Changes to proposed District Map Amendment G-956

A revised version of DMA G-956, dated December 18, 2013, has been posted on the Planning Department website for review. It contains all of the proposed and approved changes that have occurred since October 11, 2013. The following document illustrates all of the changes to DMA G-956.

Changes made to DMA G-956 are organized into four sections, each section describing a different type of revision.

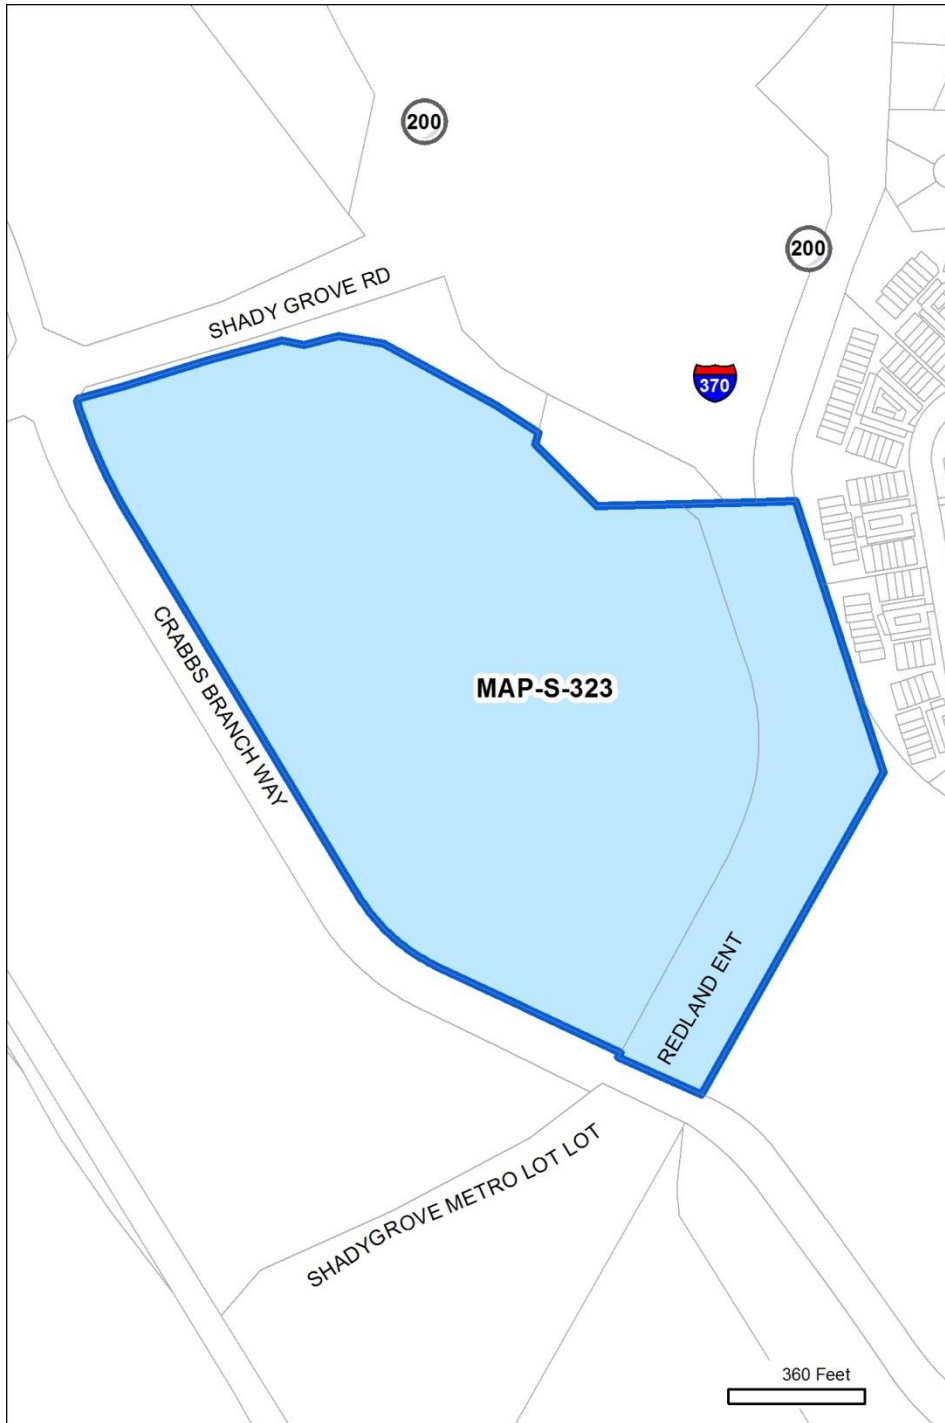
Unique ID: MAP-S-323		staff recommendation
Master Plan ID: SDYGR-06		
Master Plan:	Shady Grove	
Location:		
Existing Zone:	TOMX-2/TDR	
Proposed Conv: (10/11)	CRT-1.0 C-0.25 R-1.0 H-70 T	
Prop. Revised Conv:	CRT-0.75 C-0.25 R-0.5 H-70 T	
Category:	Staff Recommendation	
Modifications	Zone Group:	No change
	Overall FAR:	Reduced to 0.75
	Comm'l FAR:	No change
	Resid'l FAR:	Reduced to 0.5
	Height:	No change
Reason for change:		
<i>This area is currently zoned TOMX-2/TDR.</i>		
<i>The Shady Grove Sector Plan recommends this area for a maximum density of 700 DUs, achievable only through TDRs.</i>		
<i>Staff is proposing changes to the TDR Overlay in terms of how it interfaces with mixed-use zones. This change requires that only the base (non-TDR) density be mapped.</i>		
<i>The full density will still be achievable because the TDR Overlay sits on top of the CRT zone and will allow the density as specified in the Sector Plan.</i>

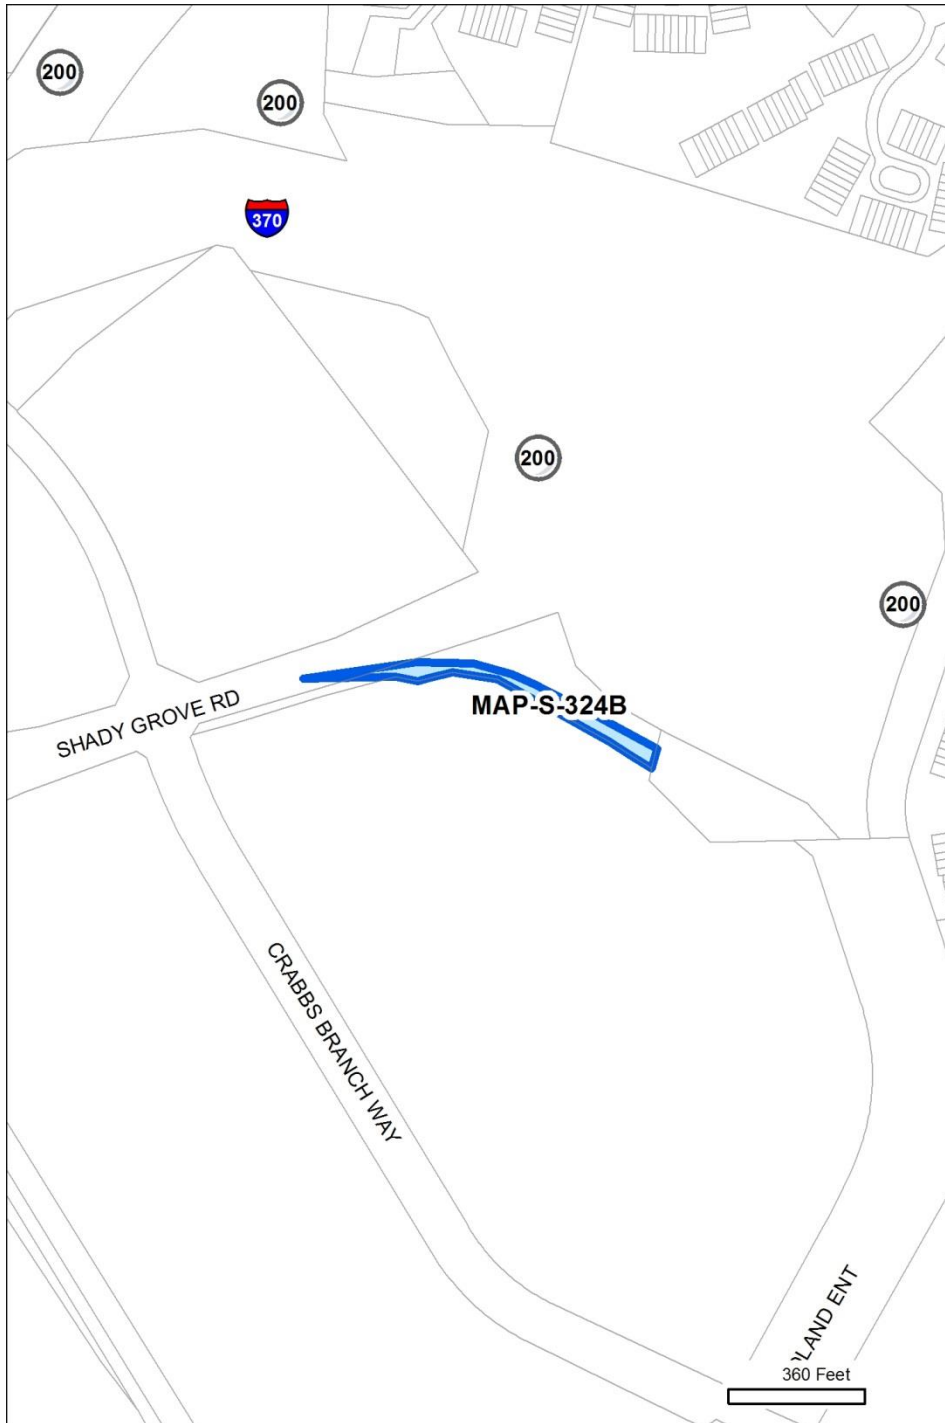
Unique ID: MAP-S-324B		staff error
Master Plan ID: SDYGR-06		
Master Plan:		Shady Grove
Location:		
Existing Zone:		R-90
Proposed Conv: (10/11)		TDR-22.0
Prop. Revised Conv:		DELETE TDR
Category:		Error
Modifications	Zone Group:	-
	Overall FAR:	-
	Comm'l FAR:	-
	Resid'l FAR:	-
	Height:	-
Reason for change:		
<p><i>This area is currently zoned R-90. It is adjacent to an area zoned TOMX-2/TDR.</i></p> <p><i>During the creation of the TDR Overlay as part of the DMA, the boundary was drawn so that it covered a portion of the adjacent R-90 zoned area.</i></p> <p><i>This is an error. The TDR Overlay should not cover the R-90 area.</i></p>

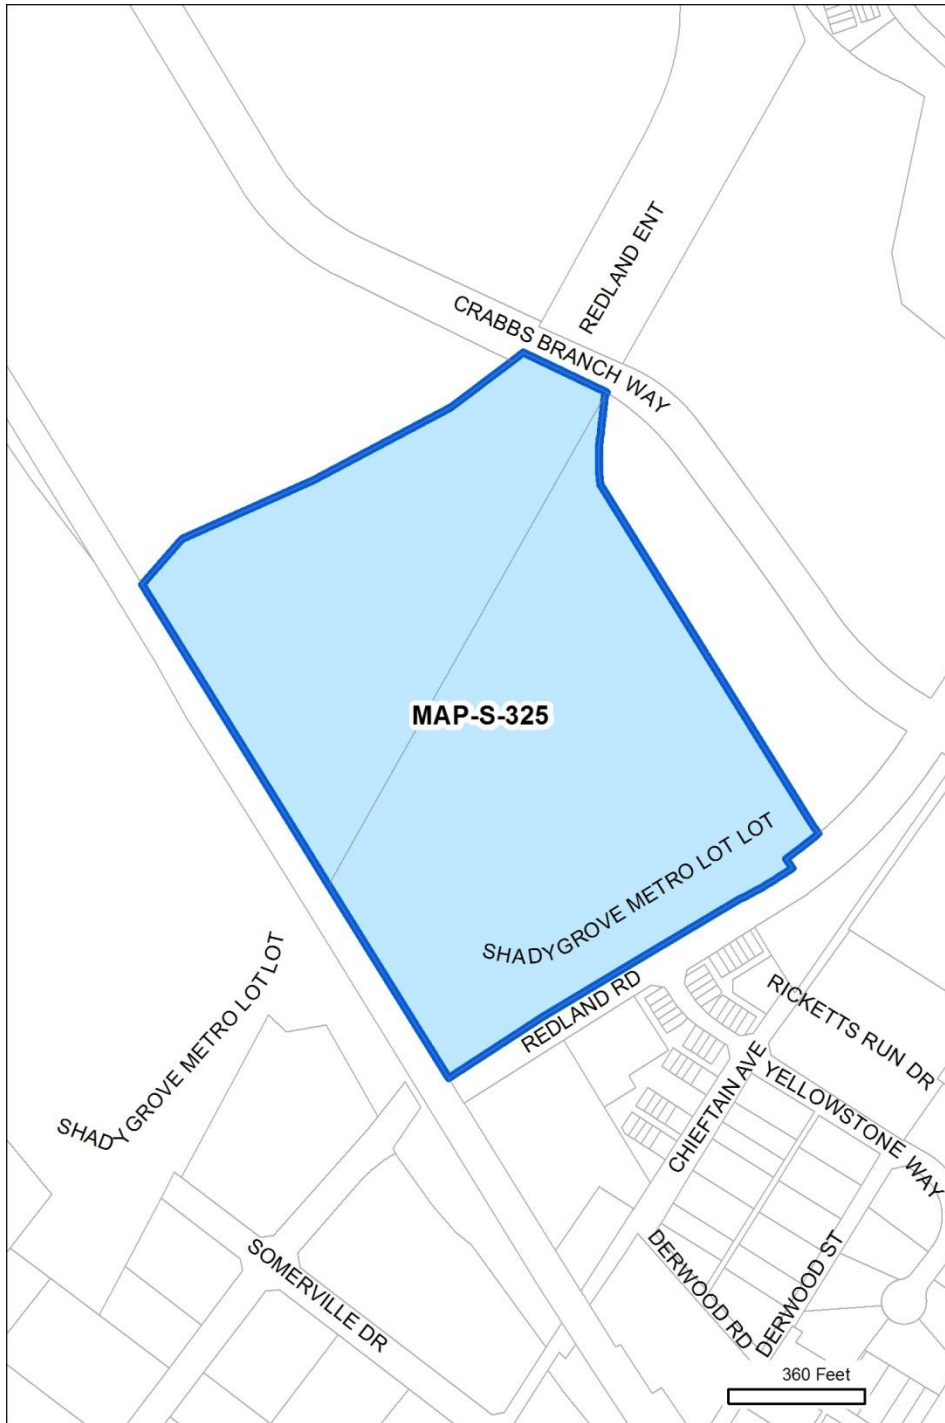
Unique ID: MAP-S-325		staff recommendation
Master Plan ID: SDYGR-07		
Master Plan:		Shady Grove
Location:		
Existing Zone:		TOMX-2/TDR
Proposed Conv: (10/11)		CRT-1.5 C-0.25 R-1.25 H-90 T
Prop. Revised Conv:		CRT-1.0 C-0.25 R-0.75 H-90 T
Category:		Staff Recommendation
Modifications	Zone Group:	No change
	Overall FAR:	Reduced to 1.0
	Comm'l FAR:	No change
	Resid'l FAR:	Reduced to 0.75
	Height:	No change
Reason for change:		
<p><i>This area is currently zoned TOMX-2/TDR.</i></p> <p><i>The Shady Grove Sector Plan recommends this area for a maximum density of 835 DUs, achievable only through TDRs.</i></p> <p><i>Staff is proposing changes to the TDR Overlay in terms of how it interfaces with mixed-use zones. This change requires that only the base (non-TDR) density be mapped.</i></p> <p><i>The full density will still be achievable because the TDR Overlay sits on top of the CRT zone and will allow the density as specified in the Sector Plan.</i></p> <p><i>In this case, the base density of 530 dwelling units will fall between 0.42 and 0.70 FAR, depending on the mix of unit types.</i></p> <p><i>Therefore, the residential and overall FAR should be reduced.</i></p>

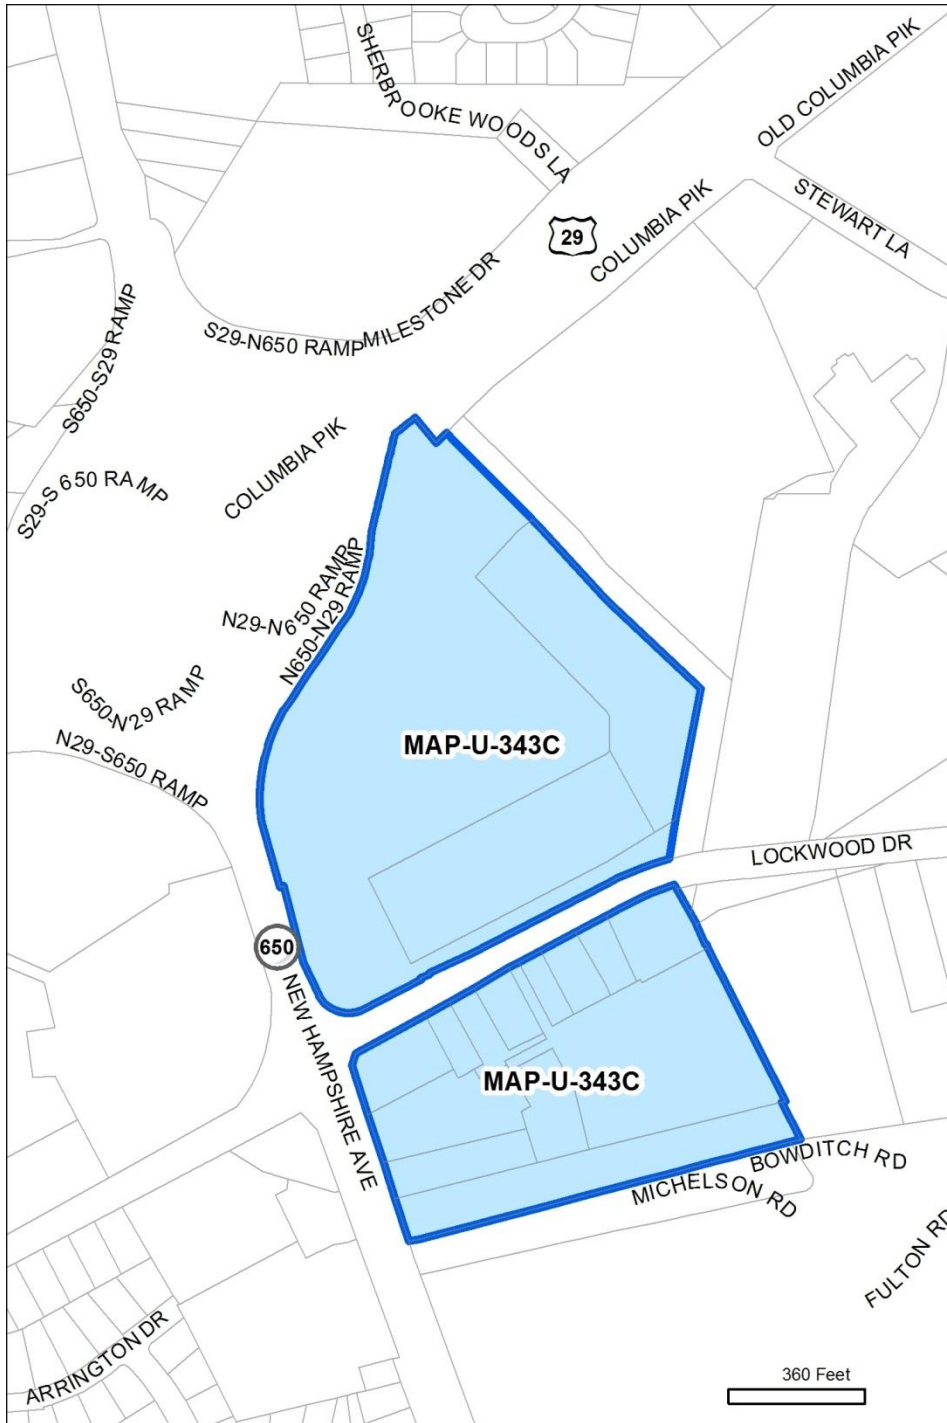
Unique ID: MAP-U-343C		Underway MP
Master Plan ID:		
Master Plan:	White Oak Sci Gateway (UNDERWAY)	
Location:	New Hampshire Ave & Lockwood Dr	
Existing Zone:	C-2	
Proposed Conv: (10/11)	CRT-2.5 C-1.5 R-1.5 H-75	
Prop. Revised Conv:	CRT-2.25 C-1.5 R-0.75 H-75	
Category:	Staff Recommended Change	
Modifications	Zone Group:	No change
	Overall FAR:	Reduced to 2.25
	Comm'l FAR:	No change
	Resid'l FAR:	Reduced to 0.75
	Height:	No change
Reason for change:		
<p><i>This area is in a Master Plan which is underway. If the Master Plan and SMA pass before the Rewrite and DMA, the DMA will be revised to reflect the new zoning.</i></p> <p><i>However, if the DMA passes first, it must convert the zones on the ground at the time. The Master Plan and SMA will then change what the DMA put down when they are adopted (assuming it's different from the DMA recommendation).</i></p> <p><i>In this case, the standard conversion for this zone was changed, and therefore this area's DMA recommendation must be accordingly updated.</i></p>

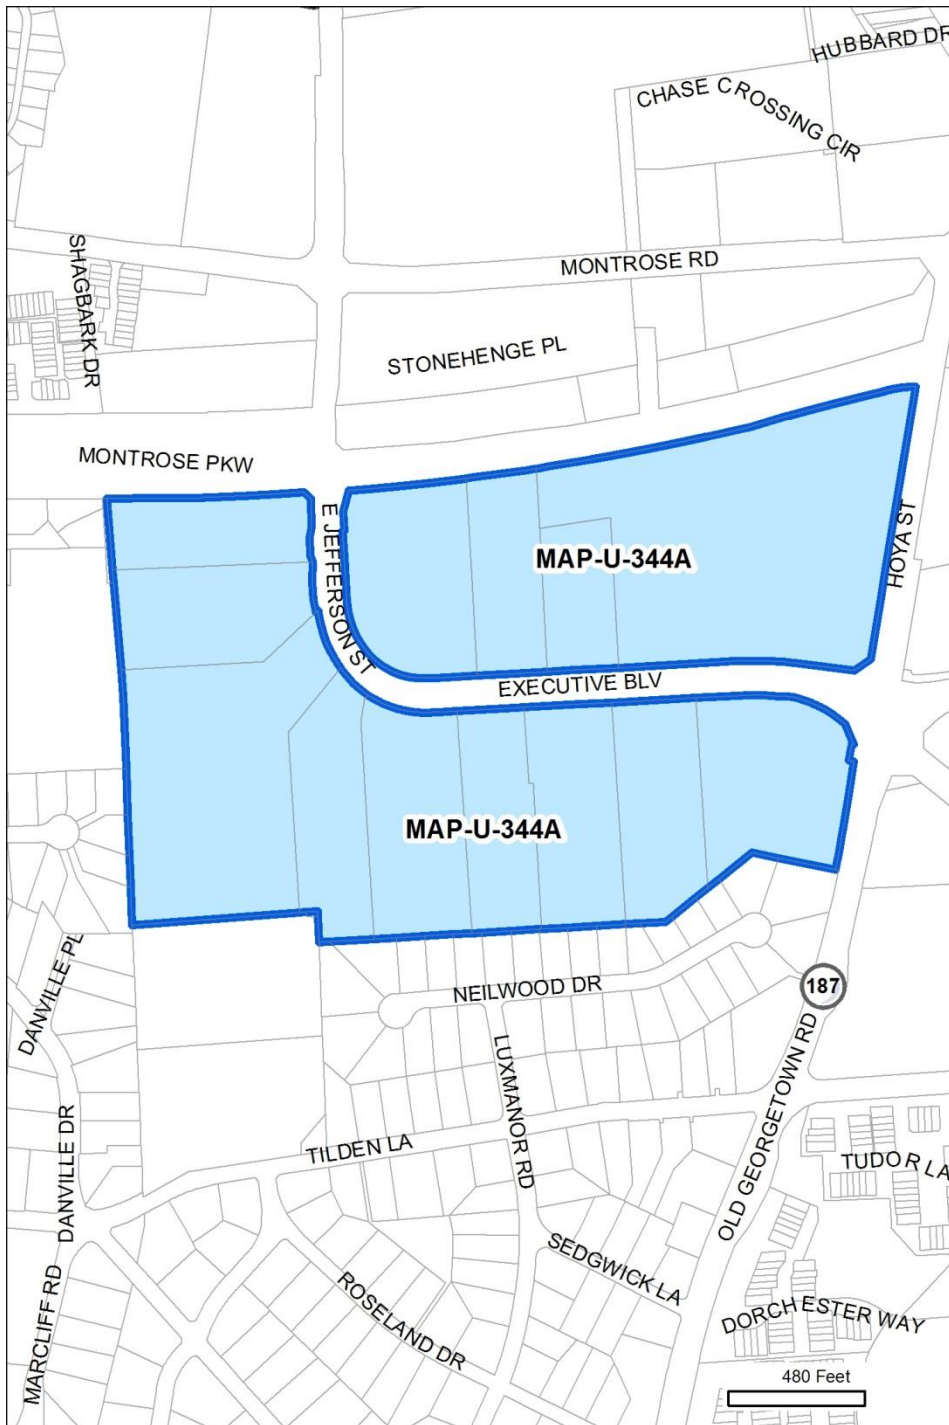
Unique ID: MAP-U-344A		Underway MP
Master Plan ID:		
Master Plan:	White Flint II (UNDERWAY)	
Location:	Montrose Pkw & Jefferson St	
Existing Zone:	I-3	
Proposed Conv: (10/11)	EOF-0.75 H-100	
Prop. Revised Conv:	EOF-0.75 H-100 T	
Category:	Staff Recommended Change	
Modifications	Zone Group:	No change
	Overall FAR:	No change
	Comm'l FAR:	No change
	Resid'l FAR:	No change
	Height:	No change
Reason for change:		
<p><i>This area is in a Master Plan which is underway. If the Master Plan and SMA pass before the Rewrite and DMA, the DMA will be revised to reflect the new zoning.</i></p> <p><i>However, if the DMA passes first, it must convert the zones on the ground at the time. The Master Plan and SMA will then change what the DMA put down when they are adopted (assuming it's different from the DMA recommendation).</i></p> <p><i>In this case, the standard conversion for this zone was changed, and therefore this area's DMA recommendation must be accordingly updated.</i></p>
